Sewer Pump Station Generator Replacement
PROJECT NUMBER: 24-26

ADDENDUM NO. 1

ISSUED THIS DATE: June 20, 2024

EXISTING GENERATOR VAULT INTERIOR

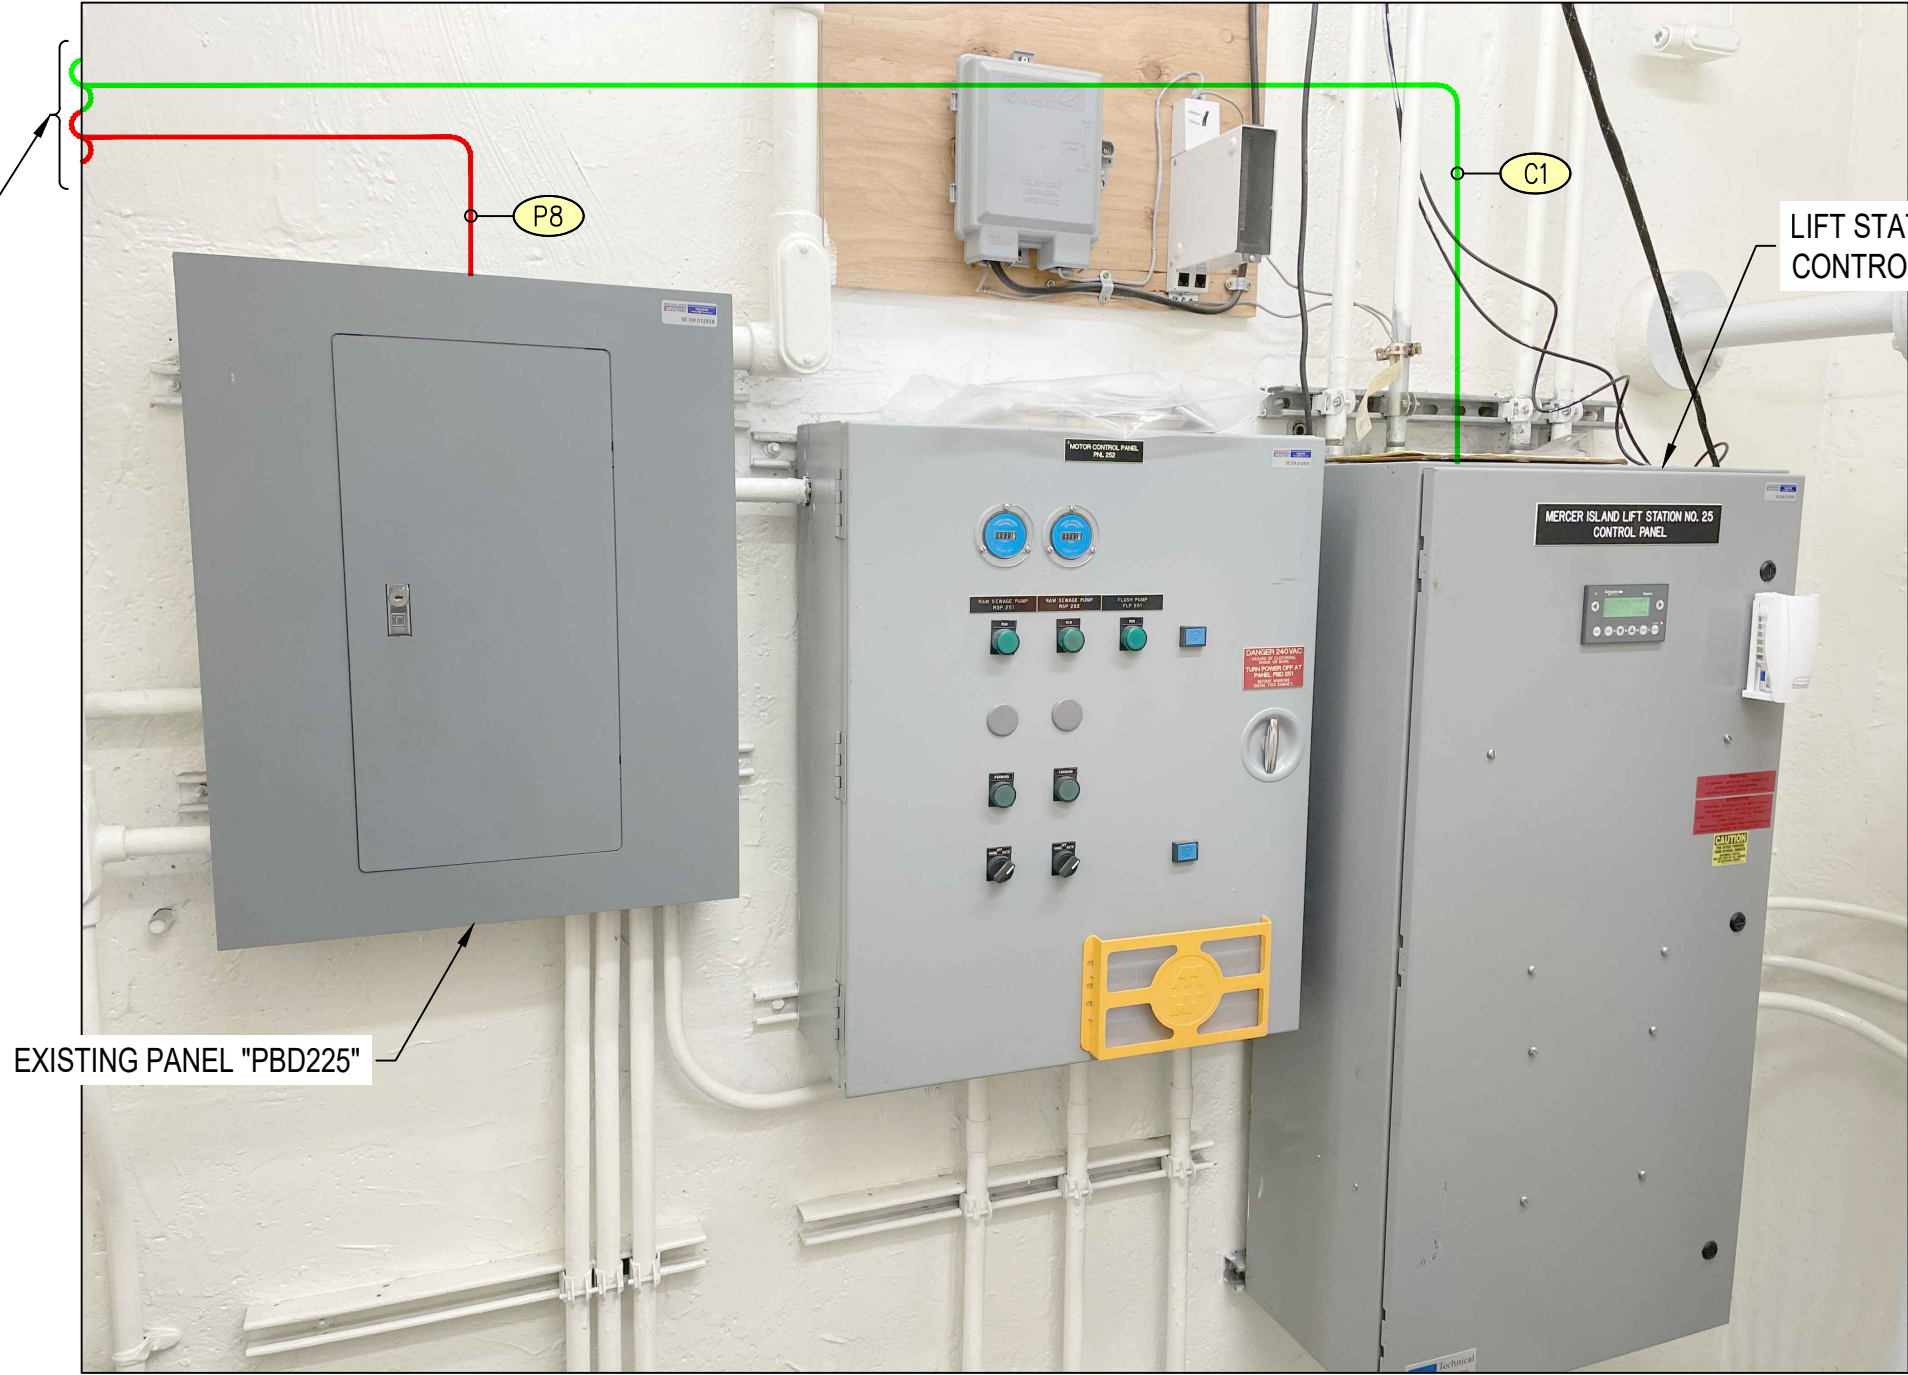
Ref	Question	Answer
1	LS 25 one-line diagram shows installing a main service disconnect before the meter base. As this service is 240-volt 3 phase, the disconnect is required to be installed after the meter. Page E07 indicates the service feeder enters the disconnect first. We believe that it enters the meter base first. The new equipment pedestal layout would require the meter to be relocated and it does not appear there would be enough wire to reach the new meter location. Please advise.	According to As-Built drawings for the site, the existing disconnect was installed ahead of the existing meter. We have revised the drawings with the existing meter ahead of the proposed main service disconnect to comply with PSE standards. Existing conductors shall be replaced with proposed conductors. Refer to the Additions and Modifications to the Contract Documents section in this addendum for additional information.

Ref	Spec or Drawing	Location and Description of Change
A	DWG No. E06	Existing meter placed ahead of proposed main service disconnect switch.
B	DWG No. E07	Revised callout to include clarifying language.
C	DWG No. E09	Revised location of meter and disconnect on electrical equipment pedestal. Revised conduit and conductor schedules.
